SUBJECT: Division Lever Return  
Mechanism. LA-5 and LA-6  
Models

DATE: March 7, 1934

This Bulletin, Plates 1 to 4 inclusive, illustrates and describes recent improvements to the division lever return mechanism. It also explains its function and how the original mechanism may be converted.

#### VIEW SHOWING CONVERTED MECHANISM

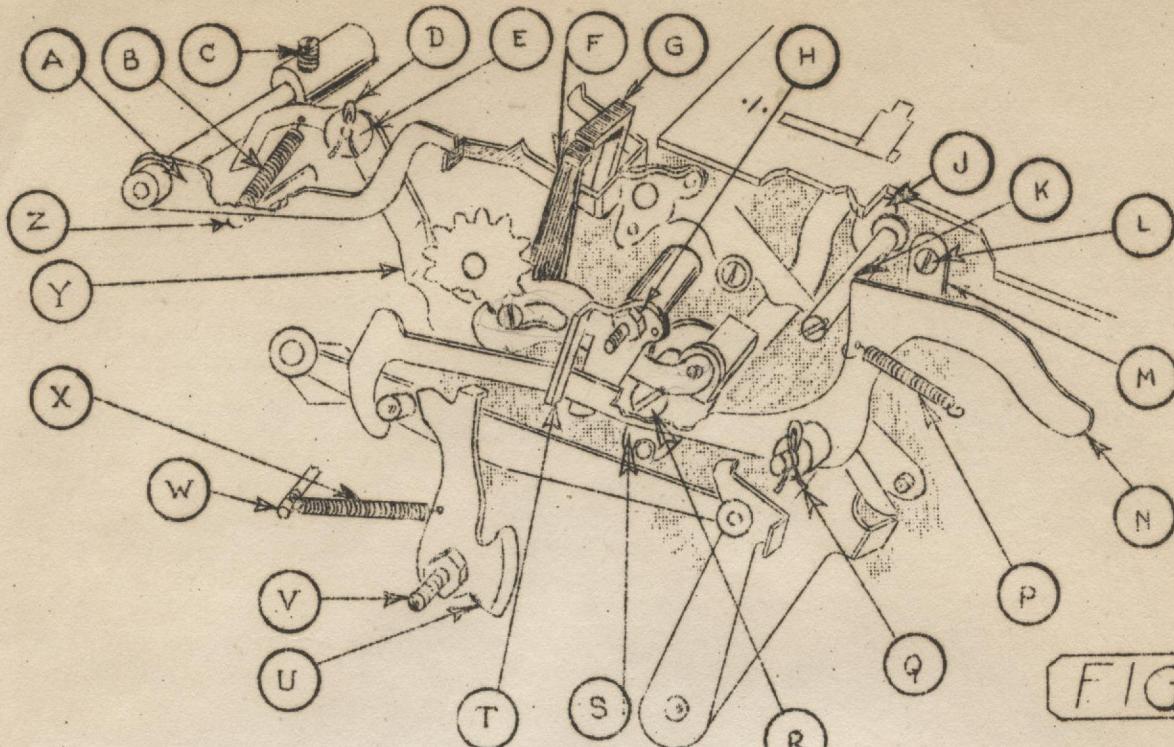
During automatic division, when the extreme left position is reached, stud (G) contacts (D) causing it to pivot at (E). As (D) pivots downward, blank (Q) which is supported by lug (C) pivots at (R) and positions downward. In doing so lug (K) positions at (X) and after the figures are registered in the lower dials and the trip lever is tripped, arm (V) drops downward where it is engaged by (W) which results in the positioning of lug (S) against the bumper pad (T). As lug (S) travels toward (T), lug (K) engages (L) and pulls the division lever (J) into neutral position.

- 22- Attach spring (P) to anchor (N) and blank (Q). See Figure 1.
- 23- Install (N) on the new style screw stud 4750 (M) while installing (Q) on stud (U). See Figure 1.

- 24- Adjust (Y) so that the lug which engages stud (G) is aligned with the surface of the carriage support arm. See Figure 1. Also see (F) and (G), Figure 2.

- 25- Adjust lug (C) upward or downward so that lug (K) clears the 40-721x2 shown as (L), by approximately  $1/32"$ . See Figure 1.
- \*26- Install trip arm assembly (A), shown in Figure 2, and adjust as explained on Plate 8, Machine Service Bulletin 161.

- 27- Attach (AA) to (Z). See Figure 1.
- 28- Install carriage on machine.

FIG. 2

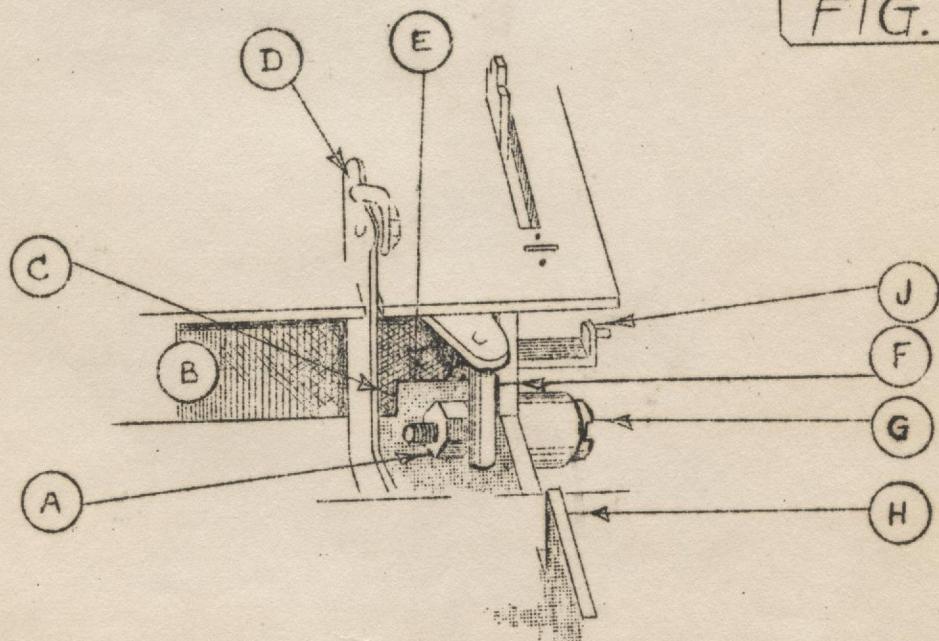
VIEW OF ORIGINAL MECHANISM TO BE CONVERTEDTO CONVERT THE MECHANISM OF LA-6 MODELS PROCEED AS FOLLOWS:

- 1 - Remove carriage from machine.
- 2 - Remove retaining clip (Q).
- 3 - Unhook spring (P) from (T).
- 4 - Replace guide blank 40-7260, shown as (K), on Plate 28, Machine Service Bulletin 161-B, with 4726. Loosen screw (H). Position guide blank (T) upward. Tighten screw (H).

- 5 - Remove (N).
- \*6 - Loosen set screw (C) and withdraw trip arm assembly (A).
- 7 - Remove retaining clip (D) and washer (E). Unhook spring (B).
- 8 - See Figure 3, Plate 3.

- 9 - Remove screw (R).
- 10 - Remove the old style 40-719 assembly (Y) together with the old style 40-721 (S). Install the 40-721x2 and carefully insert screw (R).

- 11 - Remove screw (V) and blank (U). Grind (U) as shown on Plate 4. Place (U) on (V) and install (V) in the clutch yoke and side frame and tighten securely. NOTE:-On LA-5 machines, when removing (U), unhook spring (X) from stud (W). After converting (U), attach (X) to (W).

- 12 - Lower blank (T) leaving screw (H) loose.
- 13 - Remove screw stud (K).
- 14 - Remove screw (L) and arm (M).
- 15 - Remove the 40-776 (J) and grind as instructed on Plate 4. Apply grease to the ground surface and install (J) in its original position on side frame.

- 16 - Install the 27-778 (M) in its original position and insert screw (L).

- 17- Install the new style 4750 in place of (K).
- 18- Readjust (J) and (M) by following instructions on Plate 6 of Machine Service Bulletin 131.
- 19- Install the new style 40-719xl in place of (Y) and secure with washer (E) and retaining clip (D).

- 20- Remove spring (B) from the 40-719 (Y) and install it on the 40-719xl. Attach (B) to stud (Z).
- 21- Install a #60 special washer on the shoulder of stud (U). See Figure 1.

Figure 3.

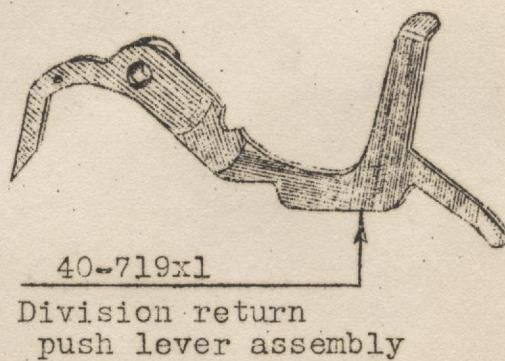
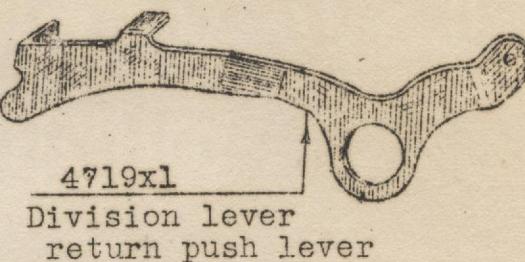
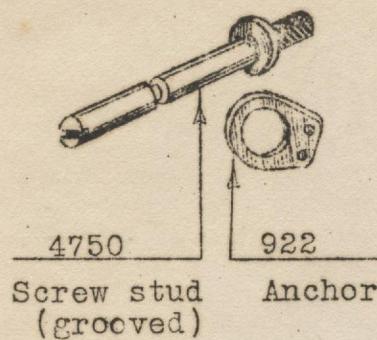
To loosen screw (G), insert the prongs of kit tool #25 between the top of nut (A) and the edge (E) of the rear keyboard cross frame (B). After screw (G) has been loosened remove the kit tool. Unhook (AA) from (Z). See Figure 1.

Before removing screw (G), insert kit tool #25 between the carriage lock (D) and stud (F) so that the prongs engage the face of nut (A) and the edge of (B) at (C). This will hold nut (A) in place against the side frame (H) while the 40-721 (J) is being replaced.
